Work Order ID 97408

Item Name: Crosstube Turning DetailL

DART AEROSPACE LTD	Work Order:	97408
Description: Crosstube Assembly (206L High Fwd)	Part Number:	D206-667-143
Inspection Dwg: D206-667-143 Rev: C		Page 1 of 2

DRAWING NO. D206-667-143	TITLE CROSSTUBE ASS'Y (206L HIGH FWD)	REV. C	DART AEROSPACE LTD ENGINEERING ORDER	D.E.O. NO. D206-667-143-C-1	SHEET NO. SHEET 1 OF 1	SCALE NTS
DRAWN <i>97</i>	CHECKED <i>ASS</i>	MFG. APPR. <i>11/07/21</i>	APPROVED <i>MD</i>	DE APPR. <i>11/07/21</i>		
DATE 11.07.15	DATE 11.07.20	DATE 11.07.21	DATE 11/07/21	DATE 11.07.21

TURNING DETAIL

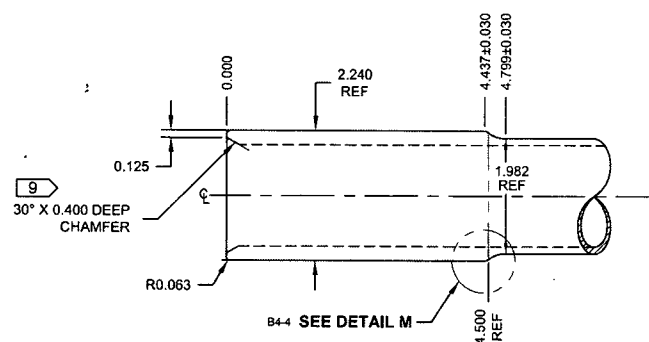
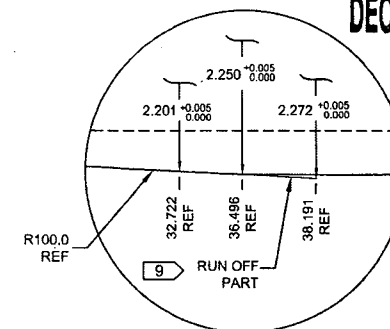
1-Fill tube with sand & install plugs DT8534 on both ends as per Folio FA087

2-Turn first side as per Folio FA087

3-Blend transition lines only, **do not sand whole tube**:

*Use mill bastard file, brush file repeatedly with file card.

*Do not use sandpaper coarser than 320 grit.

DETAIL P
BONDING STRAP INSTALLATION 2 PL

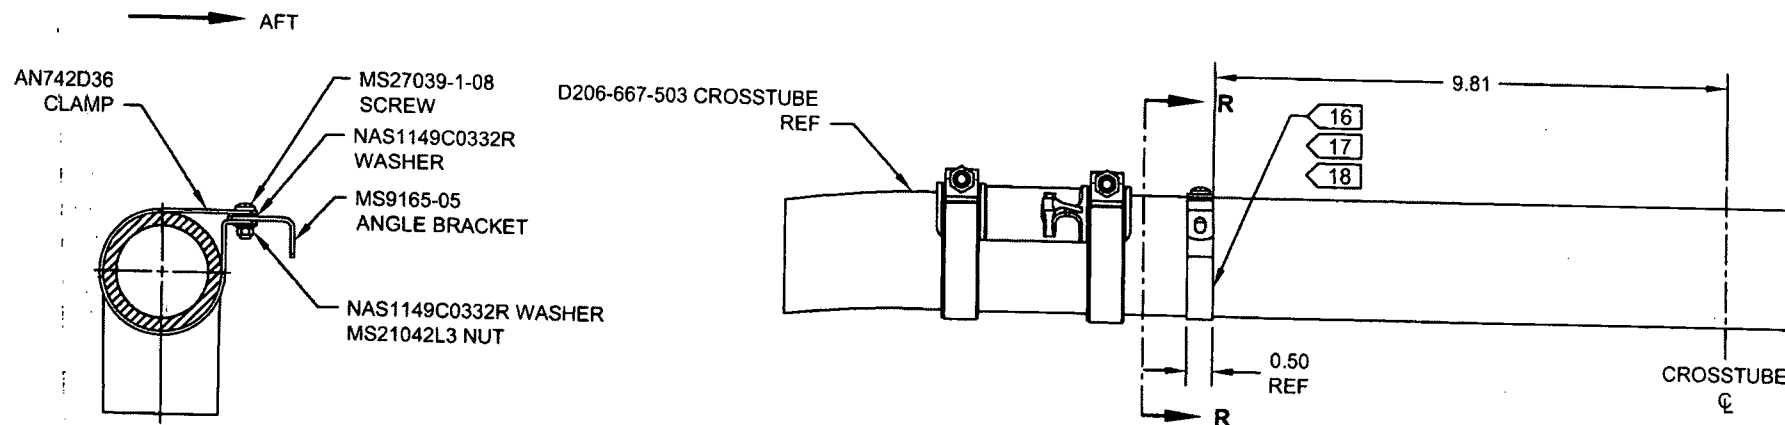
PURPOSE:

ADD ELECTRICAL GROUNDING STRAP

PARTS LIST:

ITEM	QTY -143	PART NUMBER	DESCRIPTION
1	X	D206-667-143	CROSSTUBE ASSEMBLY (206L HIGH FWD)

10	2	AN742D36	CLAMP
11	2	MS9165-05	ANGLE BRACKET
12	2	MS21042L3	NUT (OR MS21042-3)
13	2	MS27039-1-08	SCREW
14	4	NAS1149C0332R	WASHER (OR AN960C10L)

- 16) MASK AREA UNDER CLAMP PRIOR TO PAINTING
- 17) SEAL EDGES WHERE AN742D36 CLAMP MEETS WITH THE CROSSTUBE USING SIKAFLEX-241/-291 OR MIL-S-8802 CLASS B2 OR PROSEAL 890 SEALANT
- 18) PERFORM RESISTANCE CHECK TO ENSURE MAX RESISTANCE IS 10 MILLIOHMS
